BULLETIN NO. 231110

PRODUCT: 2021 MGB K-Series

TITLE: Pilot adhesive change

MODELS AFFECTED: MGB-060K thru MGB-235K

Photo 1: Original location of adhesive

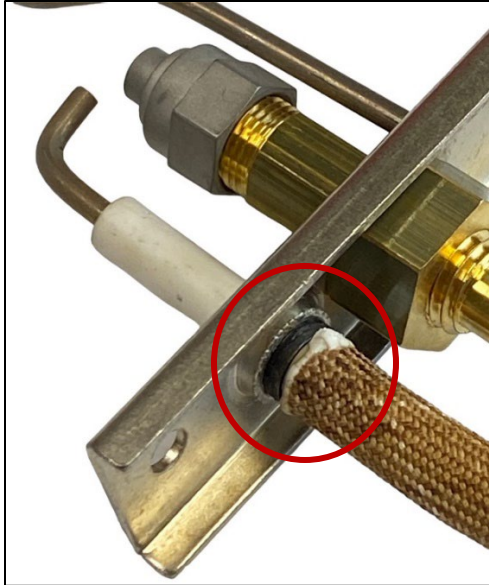
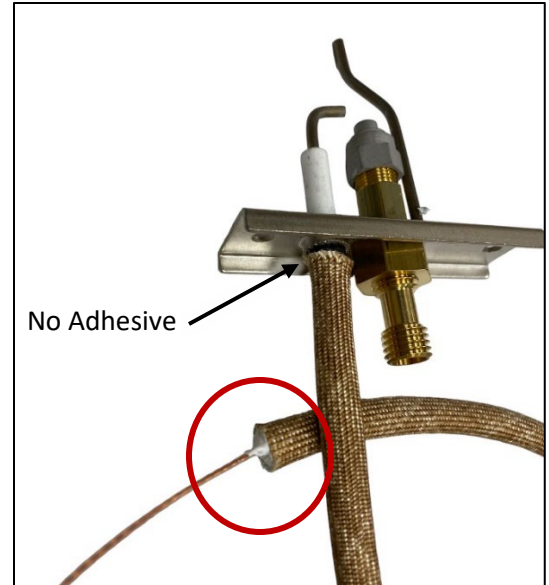
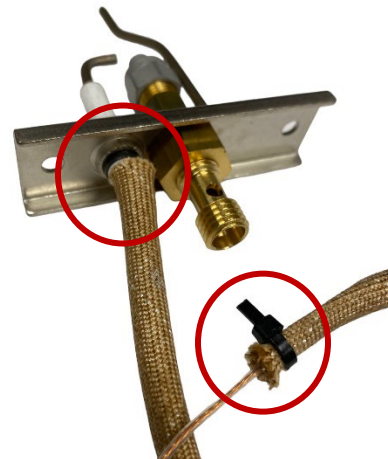
Infrequent field reports of nuisance failures associated with the MGB-K series boilers has prompted a change to the pilot assembly. The change eliminates any potential for electrical continuity created by the adhesive that holds the fiberglass sleeve in place. Electrical continuity in the area of the pilot ignitor can interfere with the flame rectification circuit and cause a nuisance shutdown.

The primary symptom is the pilot lights but the main burners are not activated. You may also notice in some cases that the ignitor continues to spark after the pilot is lit. For boilers utilizing the Resideo (Honeywell) S9361A control, the control may display an error E-57 or an erroneous error code.

To prevent any possible electrical continuity between the ignitor and ground the adhesive used to hold the fiberglass sleeve in place has been moved from the ignitor to the other end of the sleeve. This was a rolling change implemented in March of 2023. See photos 1 & 2.

Photo 2: New location of adhesive

1. Temporary fix: Roll back the fiberglass sleeve and remove the adhesive. The adhesive can be removed by scraping it away. Use a wire tie at the opposite end of the fiberglass sleeve to hold it in place so that the pilot end covers the igniter.

2. Permanent Fix: Replace the pilot assembly, kit no. 550003793. Ensure the new pilot does not have adhesive on the igniter end of the fiberglass sleeve.
